SURVEY BENCHMARK				
ALBUQUERQUE CITY SURVEY MONUMENT "NM-47-10"				
ELEV.=4970.252 (NAVD 1988)				
N=1500810.208, E=1523633.488				
NEW MEXICO STATE PLANE COORDINATE SYSTEM, (NAD83) CENTRAL ZONE, GRID BEARINGS.				
OWNER				
DAMIAN CHIMENTI INSIGHT CONSTRUCTION 1720 CENTRAL SW, SUITE B ALBUQUERQUE, NEW MEXICO 87104				
PROJECT				
3909 12TH ST. OFFICE IMPROVEMENTS Grading and Drainage Plan & Hydrologic Analysis				
PROJECT NO.	DRAWN	CHECKED	DATE	SHEET
2012.103	KC	JC	09-26-12	C1

Insight Construction
3909 12th St NW
Albuquerque, NM 87113

TCL

traffic circulation layout

1 Traffic Circulation Layout
1" = 10'-0"
scale bar 0 5 10

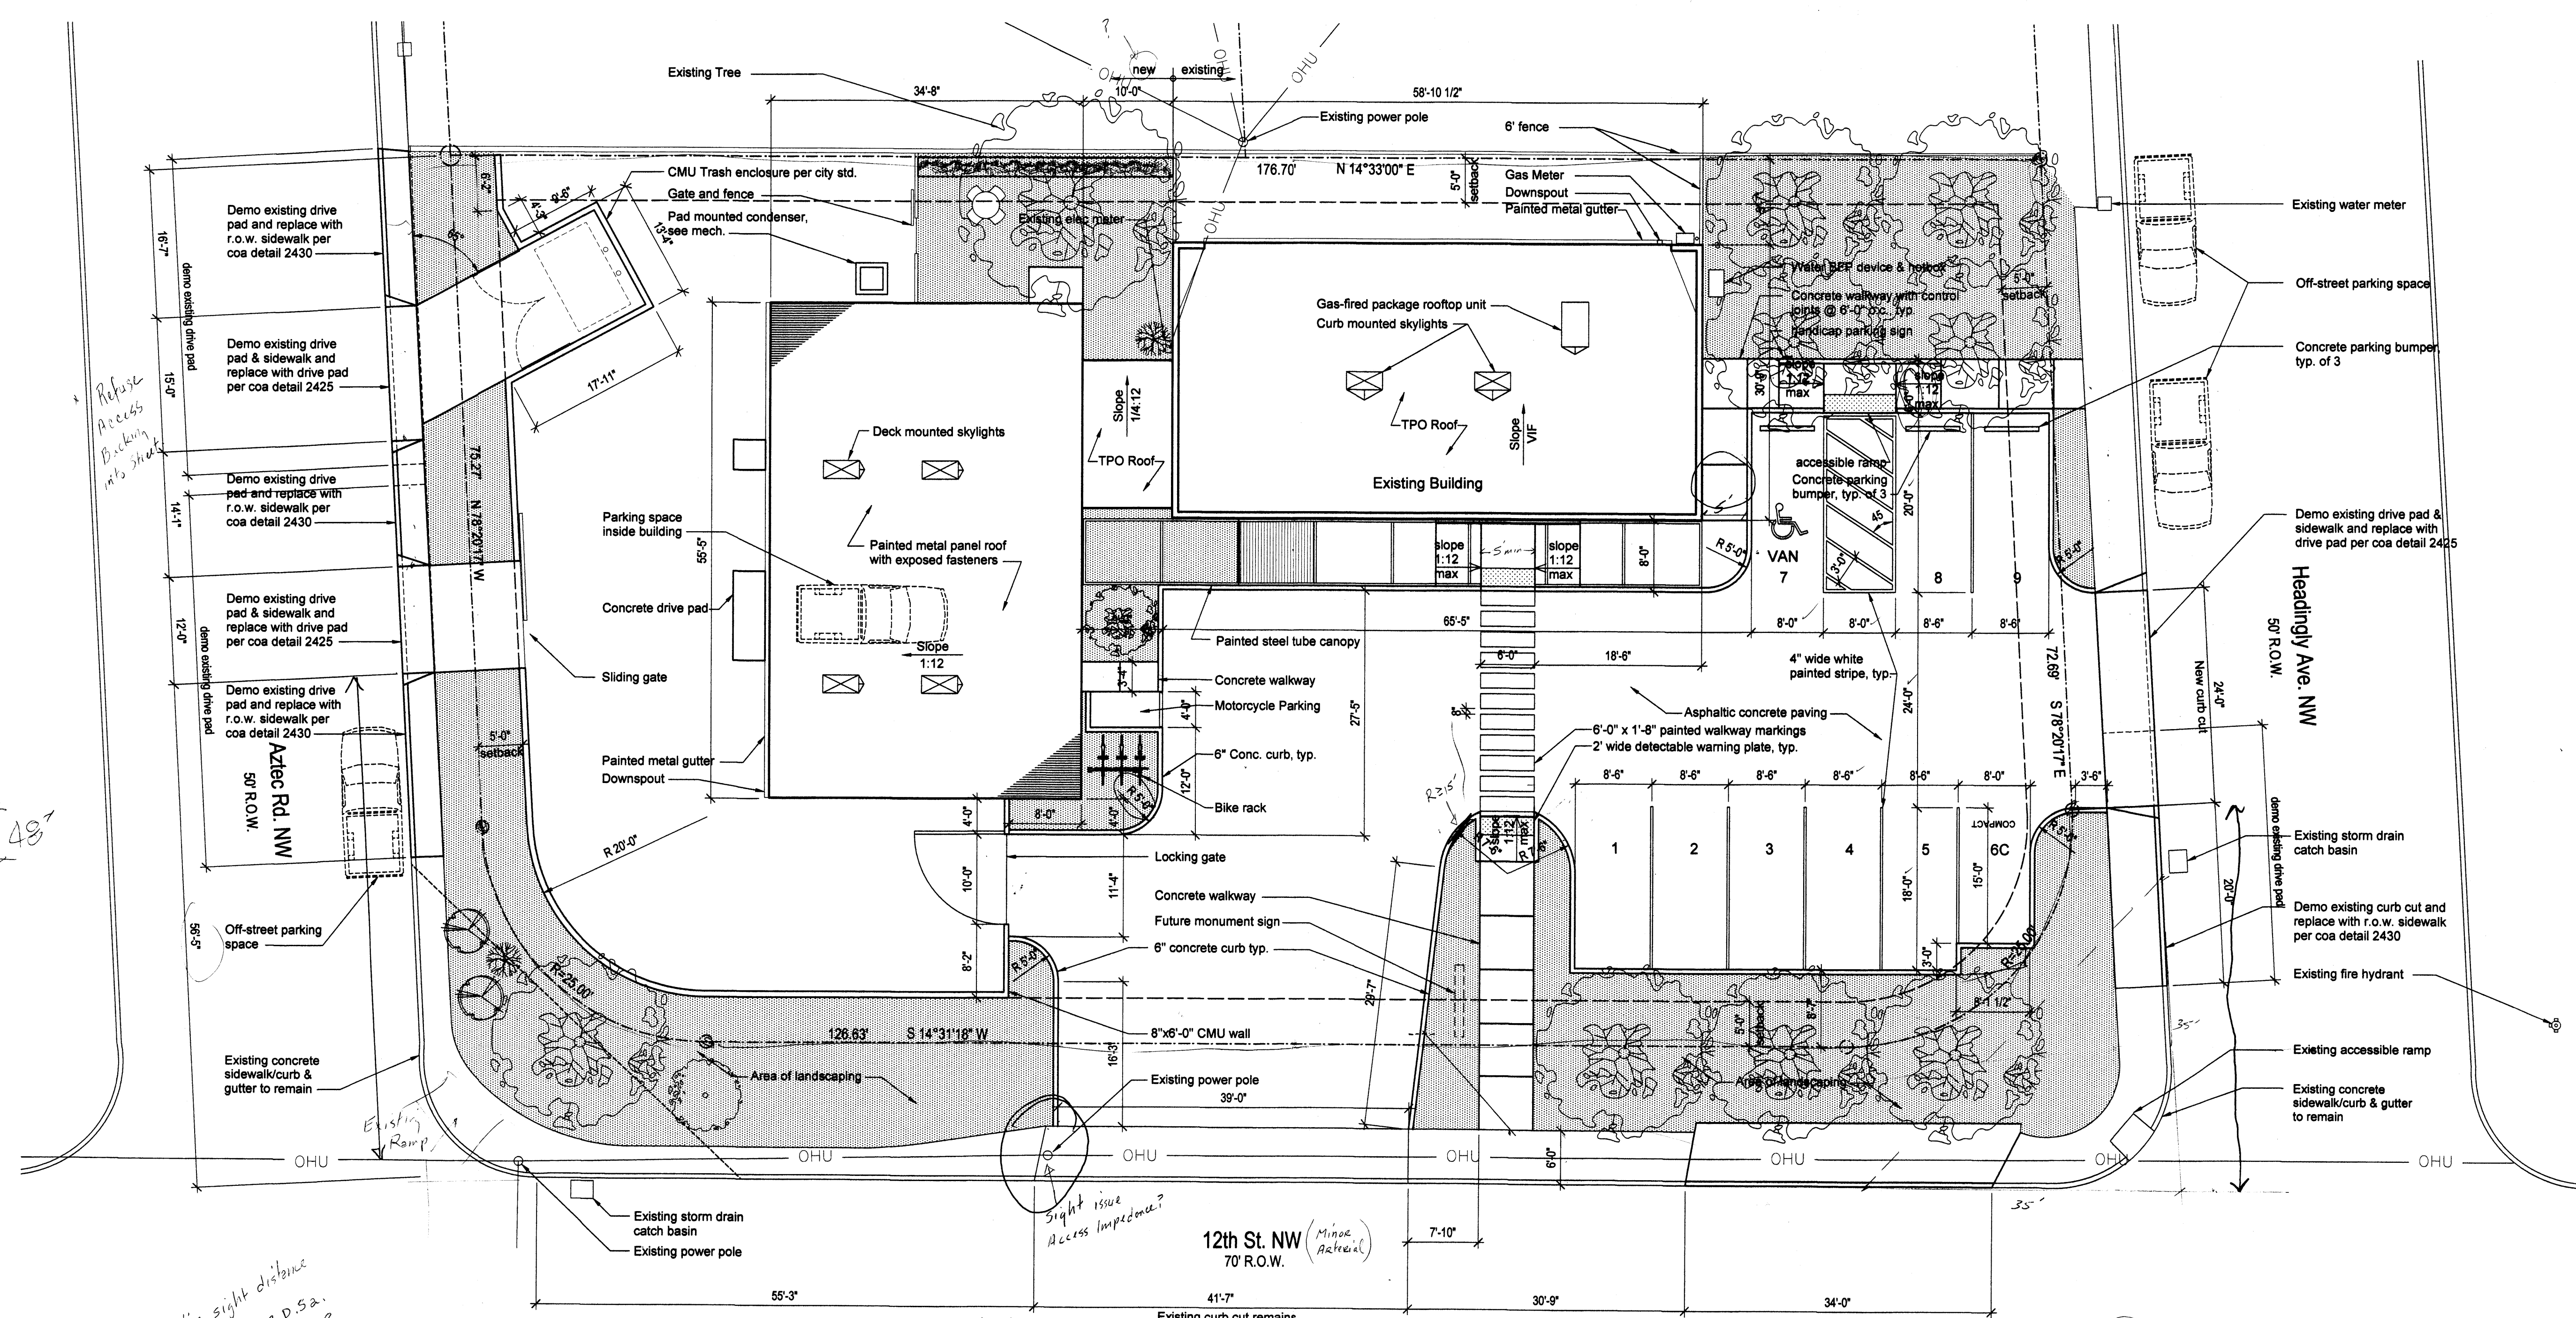
Intersection sight distance
35' - Sec. 3 D.S.A.
35' - P. 23-28
Landscaping no obstructions
between 3' - 9' above 2/4.

* Corner Cuts: Traffic Engineer

Need 20 spaces for compact
